Subject: MHI's Response to US-APWR DCD RAI No. 299-2036 REVISION 1

Response to Request for Additional Information
No. 299-2036 Revision 1

US-APWR Design Certification

RAI NO.: NO. 299-2036 REVISION 1
SRP Section: 09.03.03 – Equipment and Floor Drainage System
APPLICATION SECTION: 9.3.3
DATE OF RAI ISSUE: 4/1/2009

Figure 9.3.3-1 Equipment and Floor Drain System Flow Schematic (Sheet 1 of 2)

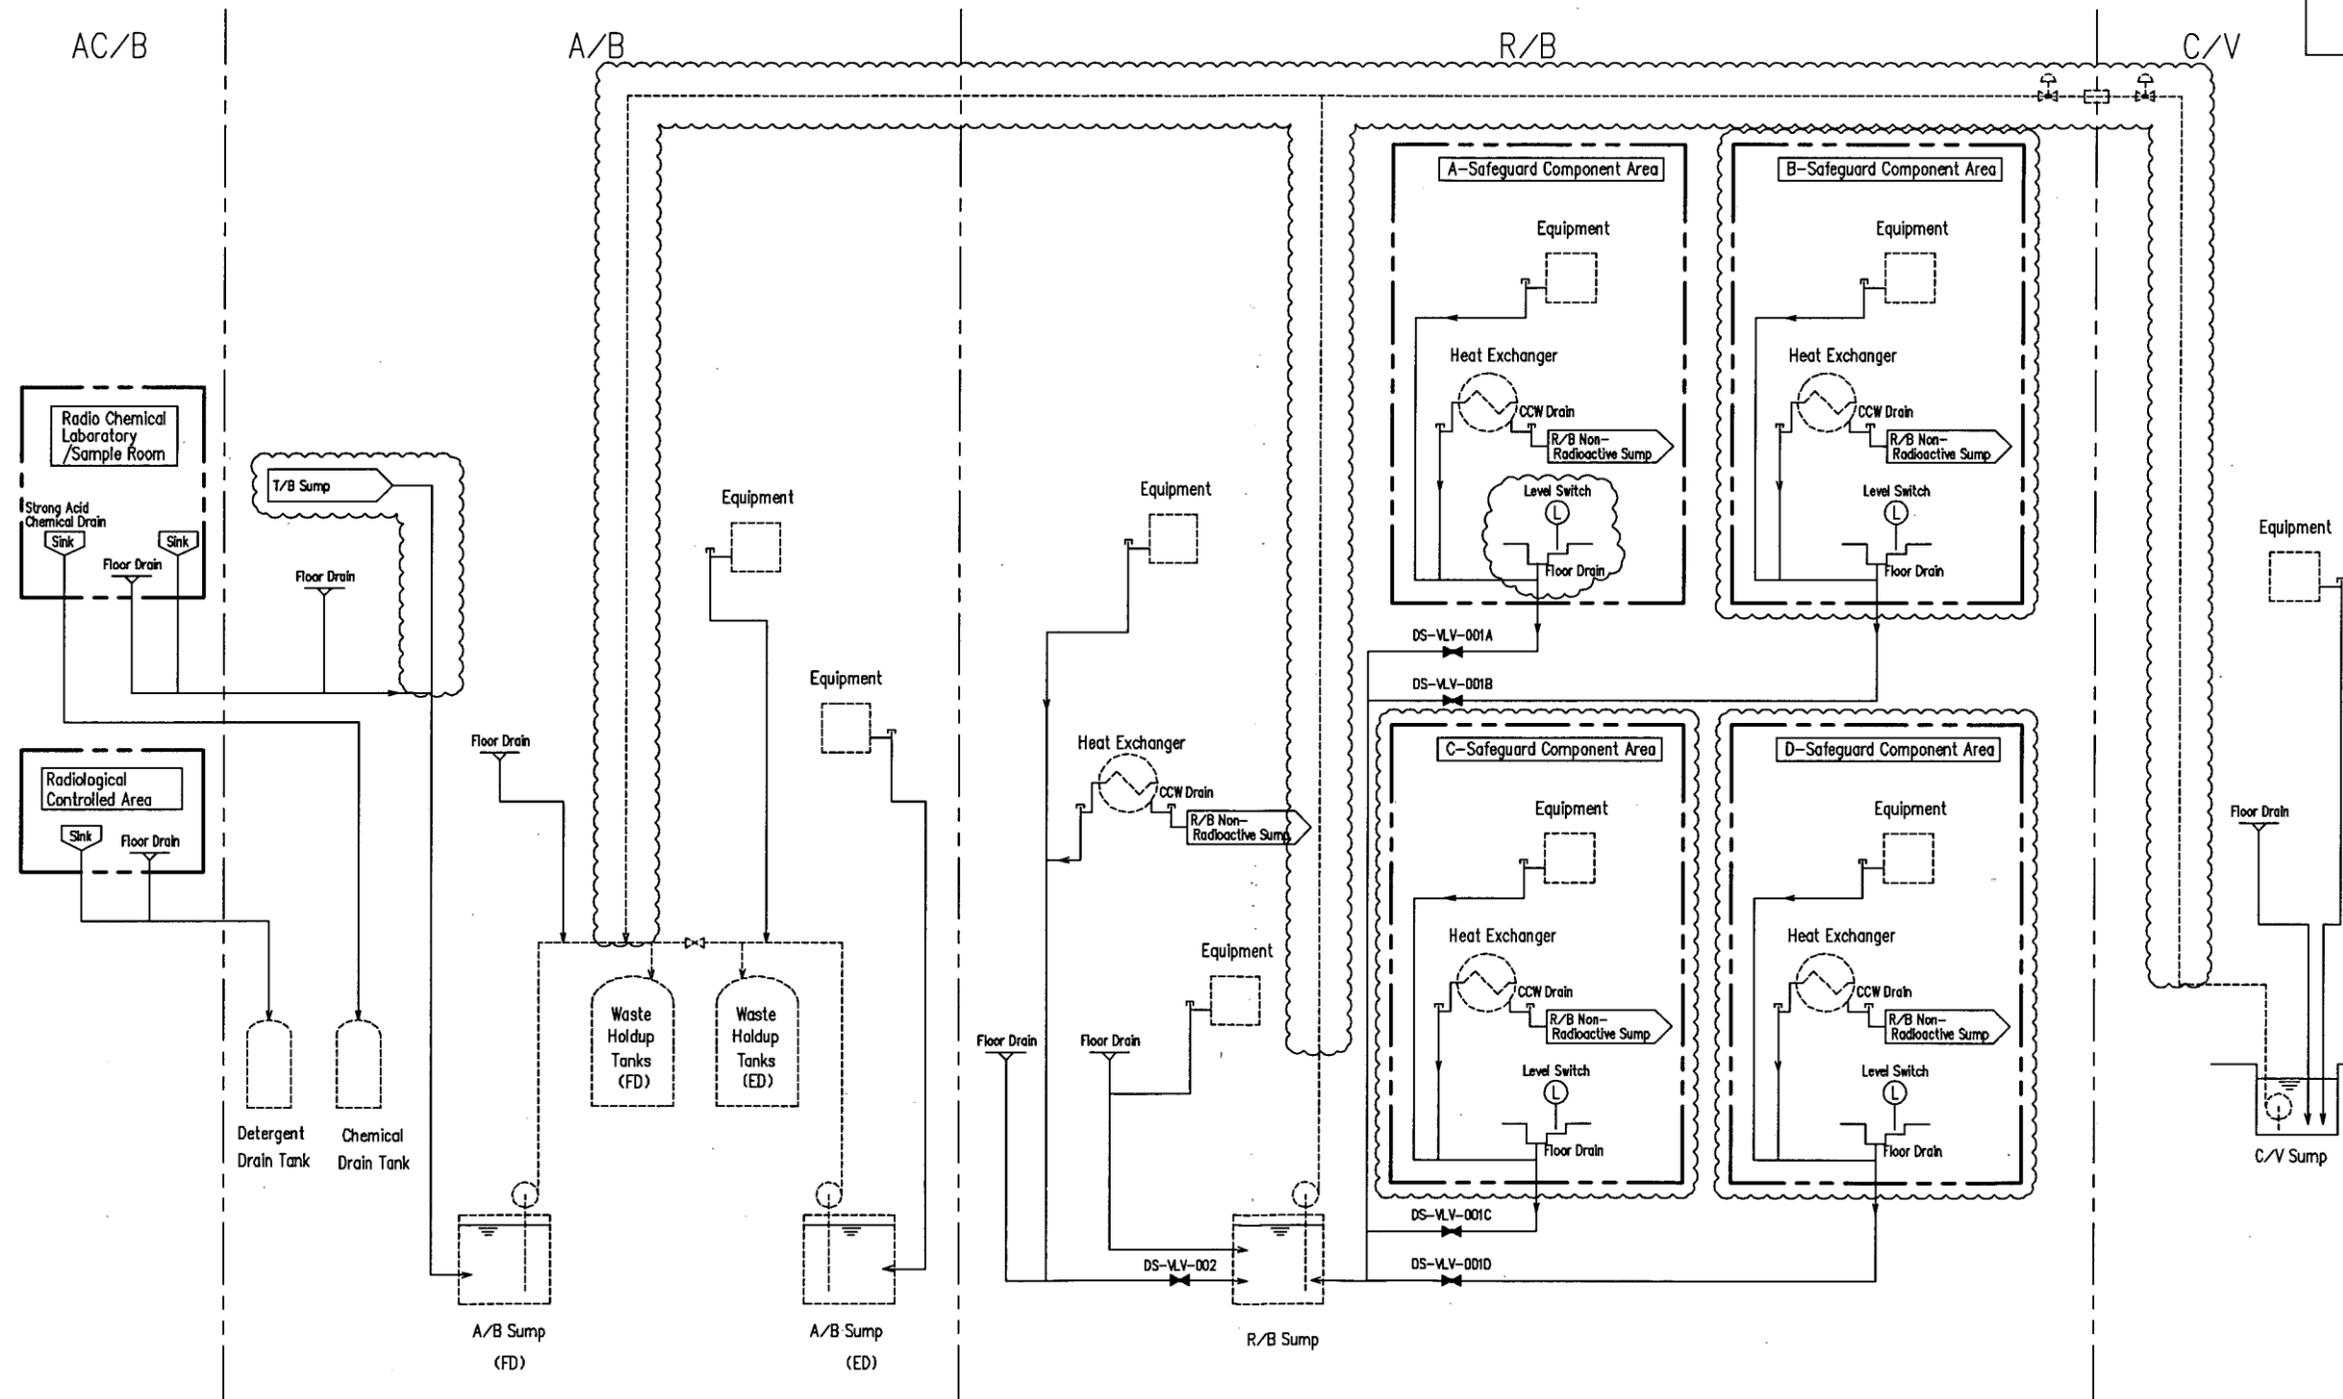
The staff determined that Figure 9.3.3-1 does not contain sufficient details for the staff to perform its review. The staff requests the applicant to provide P&IDs or drawings in the DCD that contain sufficient details including the piping and instrumentation, components classification, and quality group.

The CCW drain, shown as two streams exiting two heat exchangers on DCD Figure 9.3.3-1 (Sheet 1), contains non-radioactive liquid. These streams are therefore sent to the "R/B Non-

Figure 9.3.3-1 will be revised to show leak detection instrumentation for the safeguard equipment area and the transfer line from C/V sump. In addition, the transfer line from R/B non-radioactive sump will be revised in shape to connect to the T/B sump directly.

DCD Figure 9.3.3-1 "Equipment and Floor Drain System Flow Schematic" will be replaced with the attachment 1 to add additional information.

DCD Figure 9.3.3-1 is revised to show the valves on the piping to the A/B sump and the WWS and the routing to the A/B floor drain sump (see attachment1).

Figure 9.3.3-1 Equipment and Floor Drain System Flow Schematic (Sheet 2 of 2)

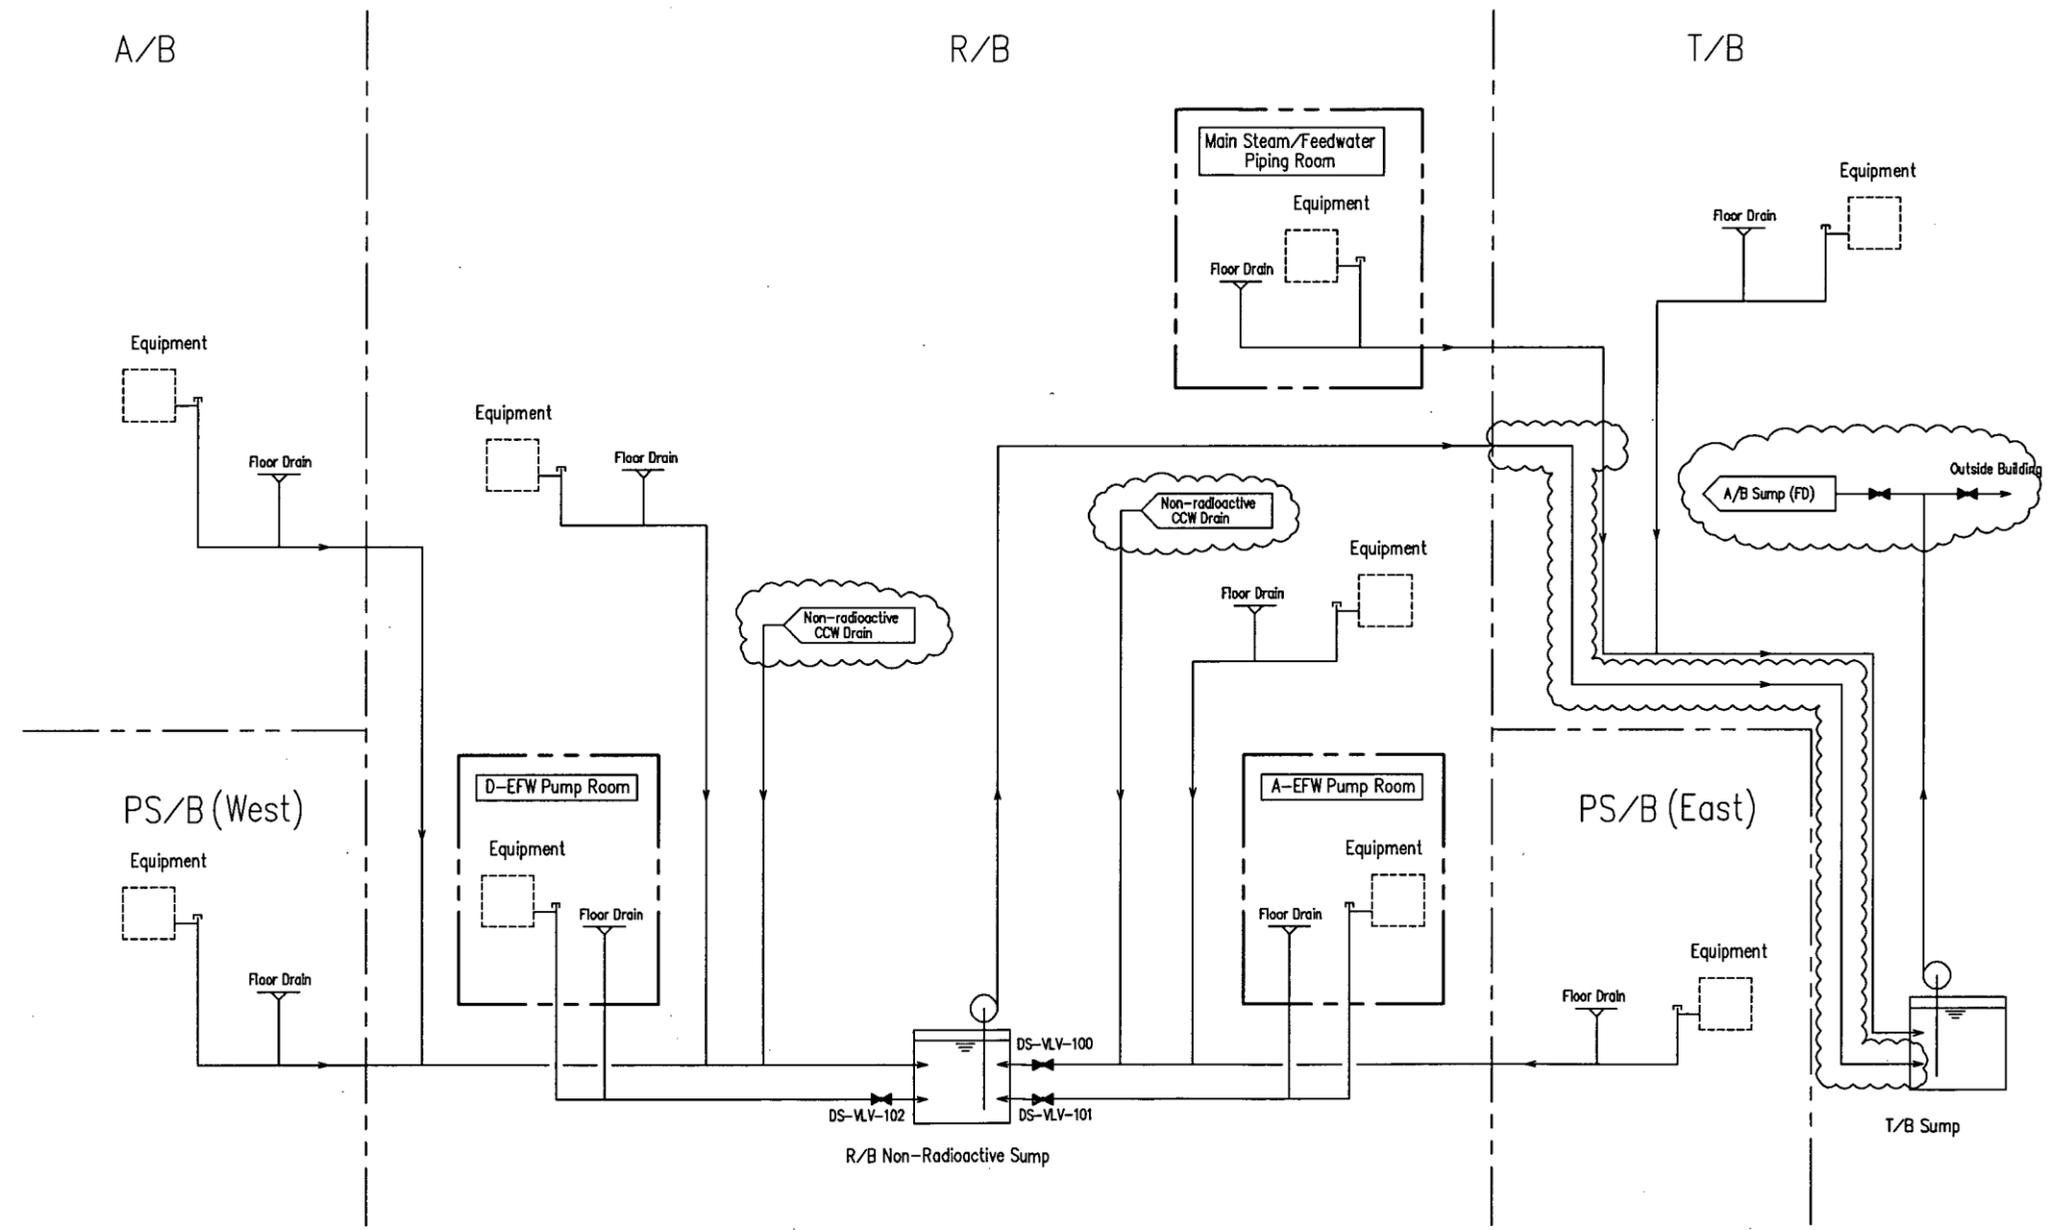
Radioactive Sump" as indicated in the figure. Figure 9.3.3-1 (Sheet 2) shows two input streams into the R/B Non-Radioactive Sump labeled as "Radioactive Area CCW Drain." These streams should instead indicate the equipment drainage from the CCW system. DCD Figure 9.3.3-1 will be revised in order to show the correct separation of non-radioactive streams and radioactive streams from the various buildings' floor and equipment drains.

DCD Figure 9.3.3-1 (Sheet 2 of 2) is revised so that the two input streams to the R/B Non-Radioactive Sump currently labeled "Radioactive Area CCW Drain" are changed to read "Non-Radioactive CCW Drain" (see attachment1).

Figure 2.7.6.8-1 Equipment and Floor Drain System Flow Schematic

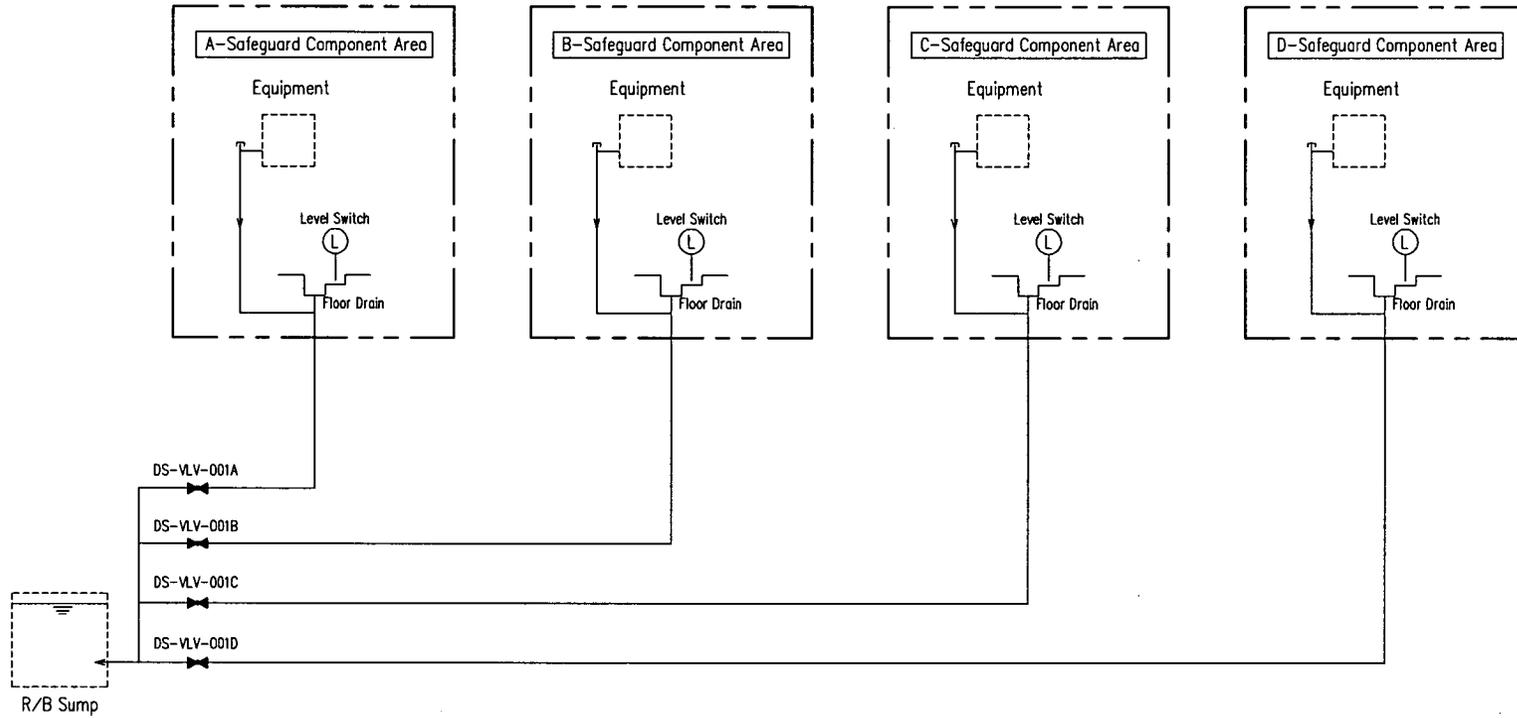
1. The "System Purpose and Function" section needs to state that an important function of the EFDS is to prevent flooding and excess water accumulation.
 2. "Location and Functional Arrangements" section needs to clarify that the WWS is for non-radioactive effluents and the LWMS is to handle radioactive effluents. In addition, it needs to emphasize that the WWS and LWMS are not connected to each other to prevent cross-contamination.
 3. "Key Design Features" needs to include a schematic or diagram showing important system, components, and interconnections.
 4. DCD Tier 1, Table 2.7.6.8-1 needs to include a Design Commitment to ensure the safety-related isolations valves are built according to ASME Code standards outlined in DCD Tier 2, Table 3.2-2. There should be an ITAAC to ensure the isolation valves are built to the requirements and standards listed in Table 3.2-2.
-

3. DCD Tier 1, Section 2.7.6.8.1 "Key Design Features" will be modified to include a schematic of the Equipment and Floor Drain System (see attachment 2).
4. DCD Tier 1, Section 2.7.6.8.1, Table 2.7.6.8-1 will have an ITAAC item added for the Equipment and Floor Drainage System which will incorporate the requirements for the drain isolation valves. The changes were described to the NRC in the response to RAI No. 242-2153, Revision 0, Question No. 14.03.03-16.
